Issue date: April 28, 2003
Revision 1

SIL No. 642

CR105X auxiliary contact failure

Figure 1

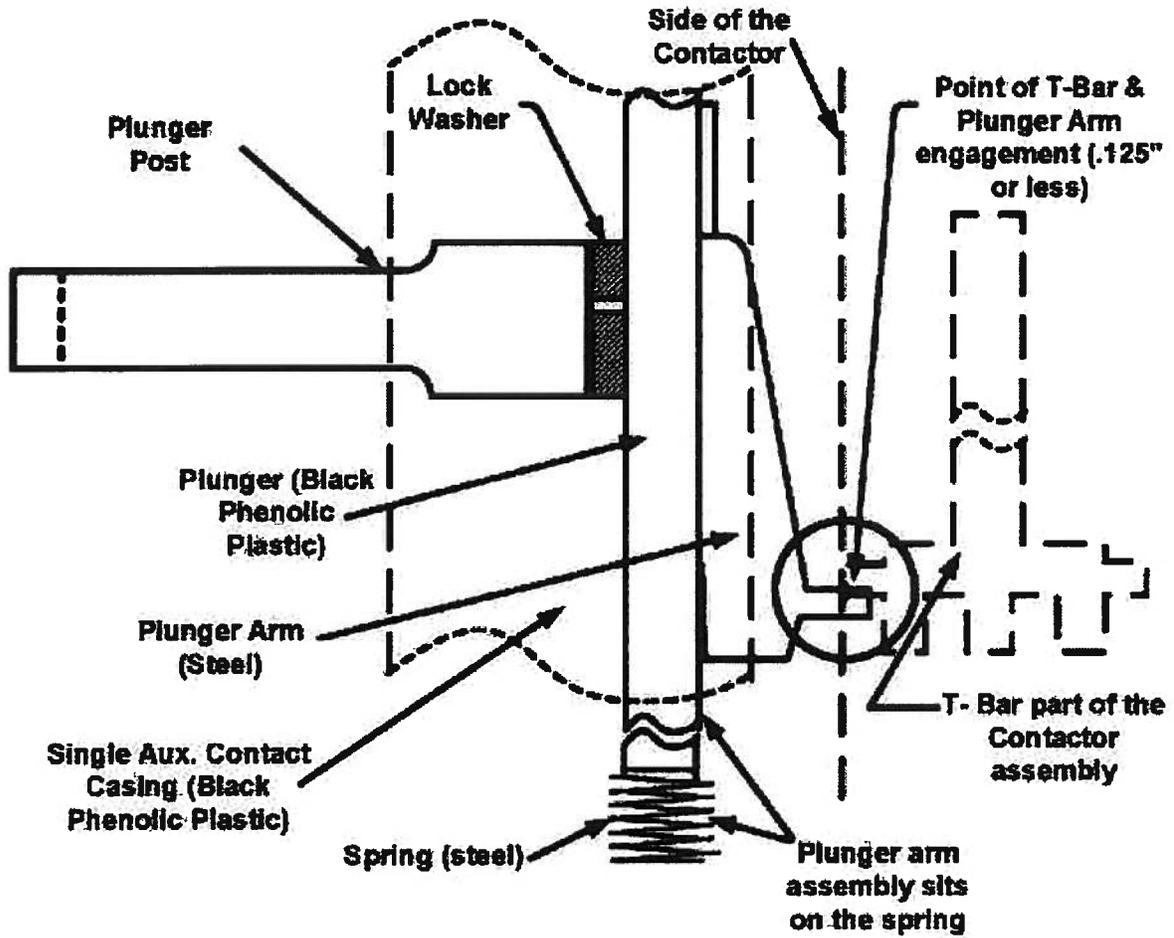
Recently at a BWR in the United States, a GE CR105X auxiliary contact failed to change state from the open to closed position. Plant troubleshooting revealed that the CR105X auxiliary contact was stuck in the open position. During repair, the auxiliary contact plunger arm was found disengaged from the T-Bar (see [Figure 1](#)), which caused the failure of the contact to change state. The cause of the disengaged plunger arm and loose plunger post was determined to be a missing #6 lock washer.

CR105X auxiliary contactors have been sold as either kits ([Figures 2 and 3](#)), or as part of an assembly. The CR105X auxiliary contacts sold as kits contain the #6 lock washer; however, the provided installation instructions did not contain guidance on where to install the #6 lock washer or the required torque to the plunger post. Assemblies shipped from the factory containing an auxiliary contact may not have the #6 lock washer installed. The plunger arm may disengage from the T-Bar causing the failure of the contact to change state if the plunger post is not properly torqued or if the #6 lock washer is not installed. There should be no gap between the steel plunger post and phenolic plunger (see [Figure 1](#)).

1. Visually verify that the #6 lock washer is installed between the plunger post and the plunger. There should be no gap between them.
2. If the #6 lock washer is missing, either install a new #6 lock washer or replace the auxiliary contact with a new one containing a #6 lock washer.
3. If the plunger arm is determined to be loose, tighten the plunger post to 4-7 in-lbs.
